**CLOVER MALL**  
BLOOMINGTON, MN

RETAIL

HOUSING

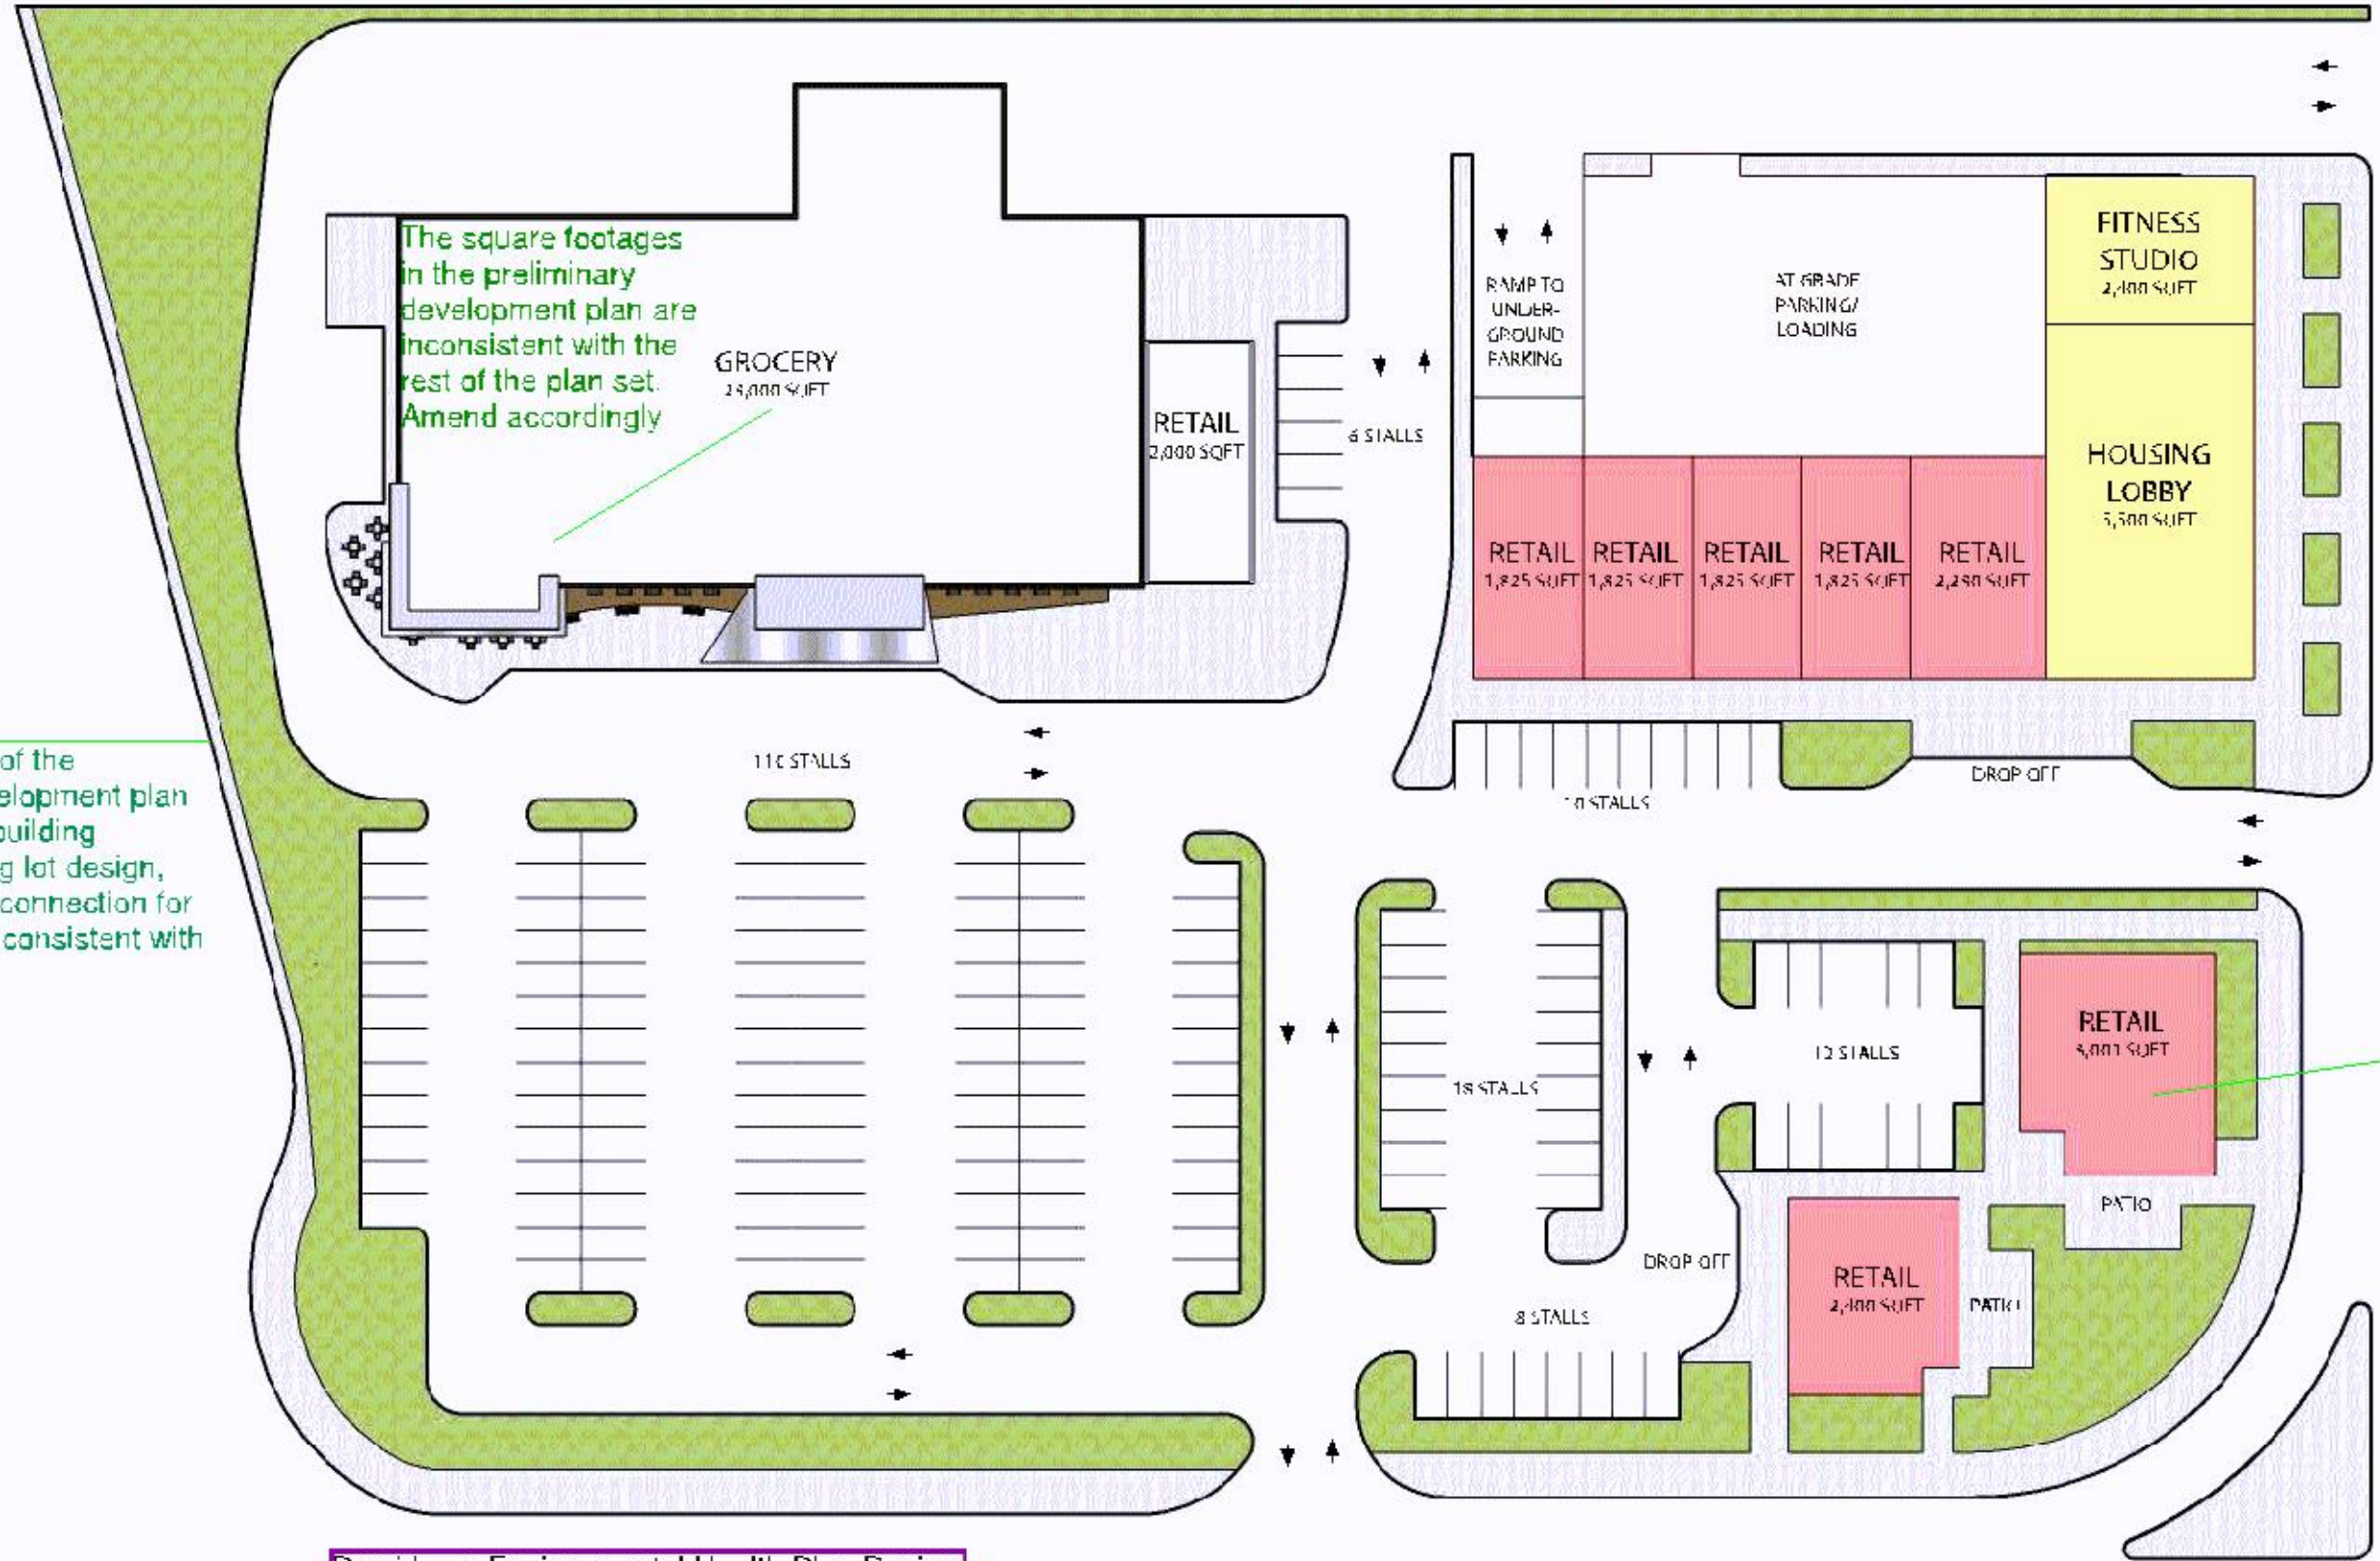
Revise sheet 1 of the preliminary development plan so the grocery building footprint, parking lot design, and pedestrian connection for the grocery are consistent with civil plans.

The square footages in the preliminary development plan are inconsistent with the rest of the plan set. Amend accordingly

Neither of the future retail buildings in the southeast corner of the site meet the minimum 4,000 square foot size requirement. Adjust the building size to 4,000 square feet. Alternatively, request a deviation for the future phase and detail how the corner and the two buildings could be designed to have a unified street presence.
